UNITED STATES PATENT AND TRADEMARK OFFICE

APPLICATION NO.	FILING DATE	FIRST NAMED INVENTOR	ATTORNEY DOCKET NO.	CONFIRMATION NO.
09/963,480	09/27/2001	Kaoru Awaka	TI-33253 (032350.B345)	8718

Office Action Summary

DETAILED ACTION

S/N: 09/963,480
REPLACEMENT SHEET/
FORMAL DRAWINGS

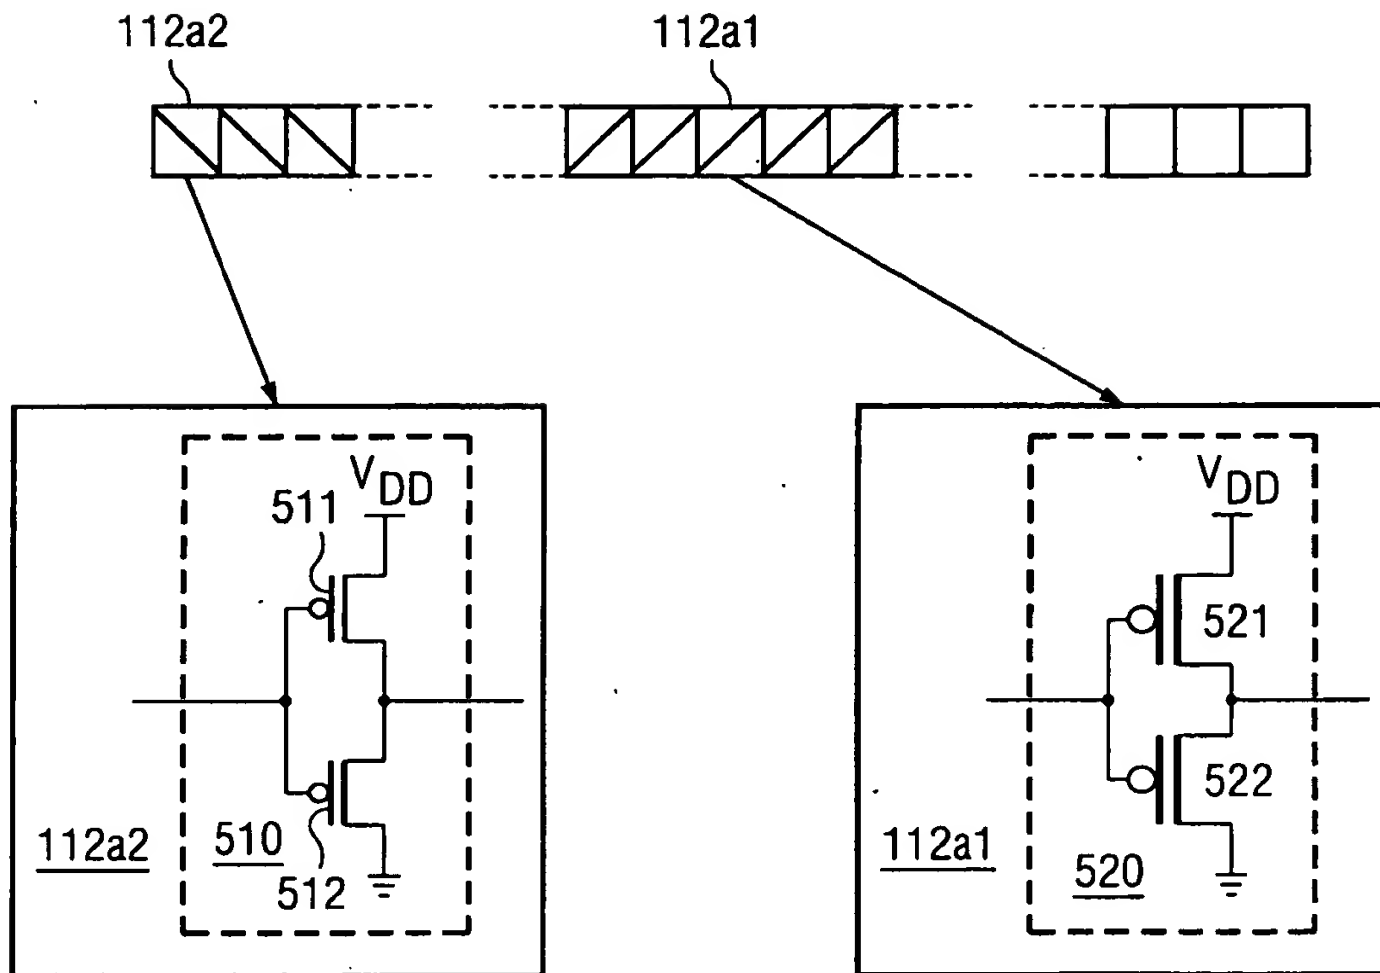
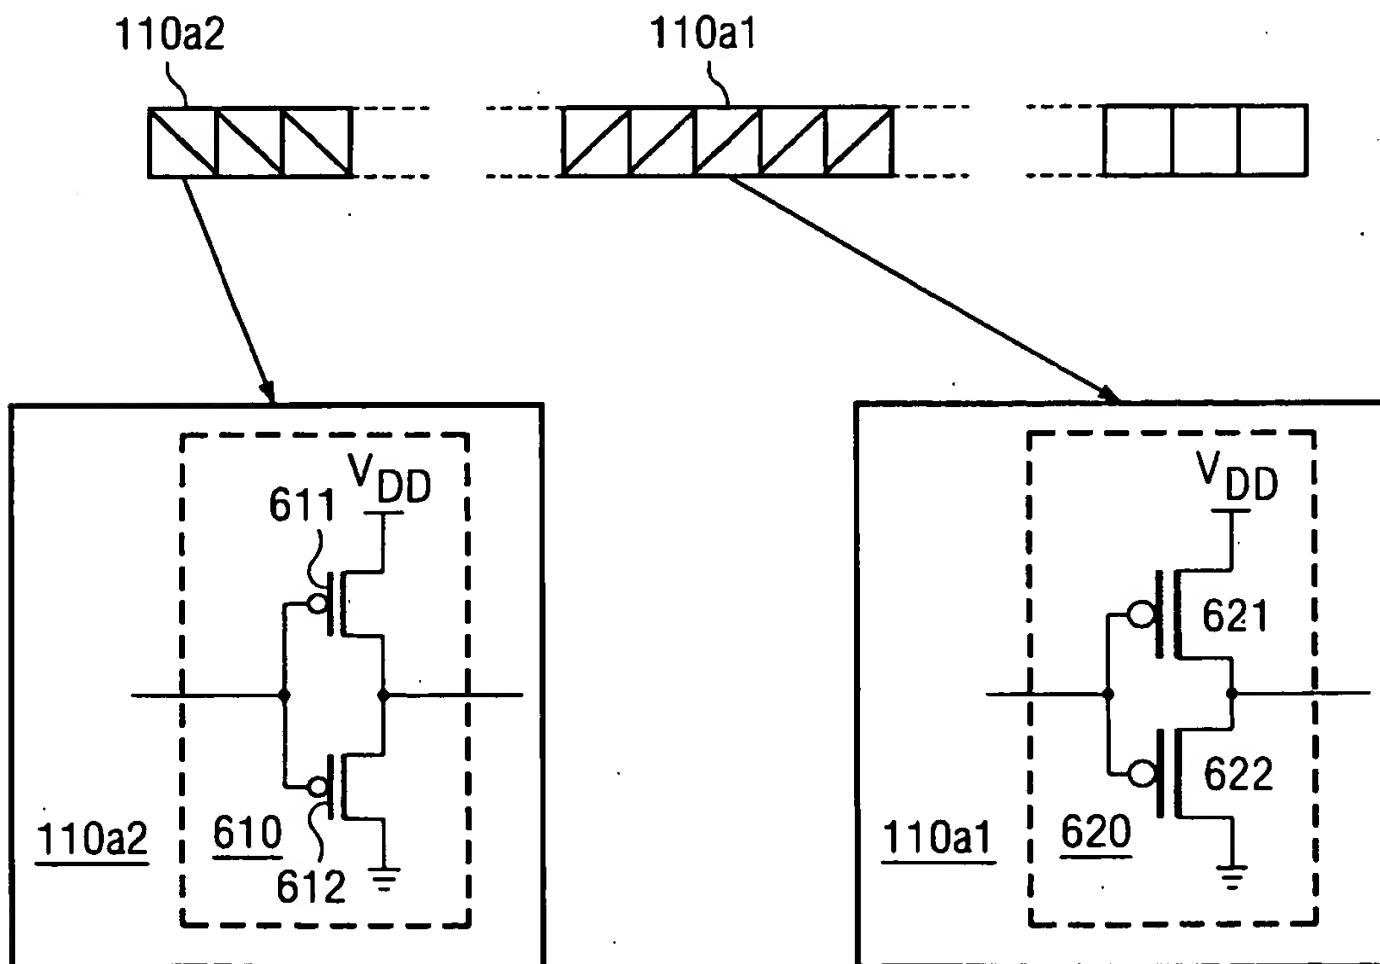
Please add Figures 5 and 6 per attached sheet.

OK to enter
